**Proposal to amend document
ECE/TRANS/WP.29/GRSG/2021/19**

Proposal for a new 04 series of amendments of UN Regulation No. 34

**Submitted by the expert from the International Organization of Motor
Vehicle Manufacturers**

“**Arrangements of approval marks**
Model A
(See paragraph 3.1.4. of this Regulation)

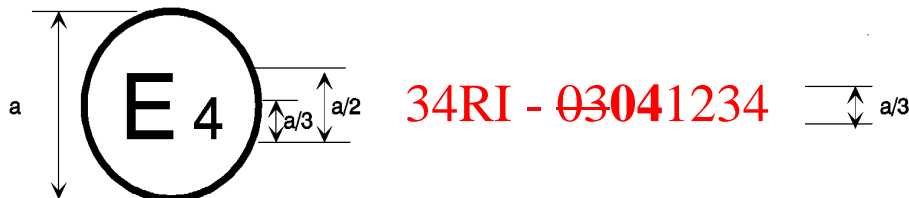
The above approval mark affixed to a vehicle shows that the type concerned was approved in the Netherlands (E4) pursuant to Part I of Regulation No. 34 under approval No. ~~02~~**04**1234. The first two digits (~~03~~**04**) of the approval number indicate that the approval was granted in accordance with the requirements of Regulation No. 34 as amended by the ~~03~~**04** series of amendments.”

Model B (vacant)
(See paragraph 3.1.5. of this Regulation)

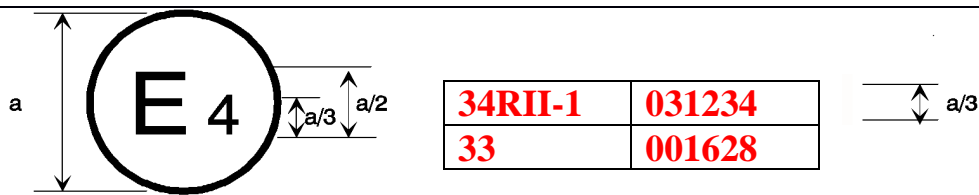
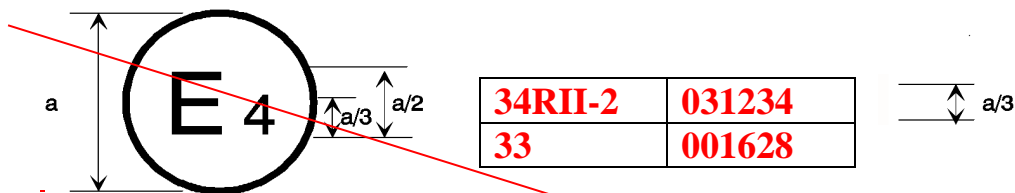
The above approval mark affixed to a vehicle shows that the type concerned was approved in the Netherlands (E 4) pursuant to Regulations Nos. 34 Parts I or IV and II-1 and 33.* The approval numbers indicated that, at the date when the respective approvals were given, Regulation No. 34 included the ~~0304~~ series of amendments and Regulation No. 33 was still in its original form.

The above approval mark affixed to a vehicle shows that the type concerned was approved in the Netherlands (E 4) pursuant to Regulations Nos. 34 Parts I or IV and II-~~2~~ and 33.* The approval numbers indicated that, at the date when the respective approvals were given, ..."
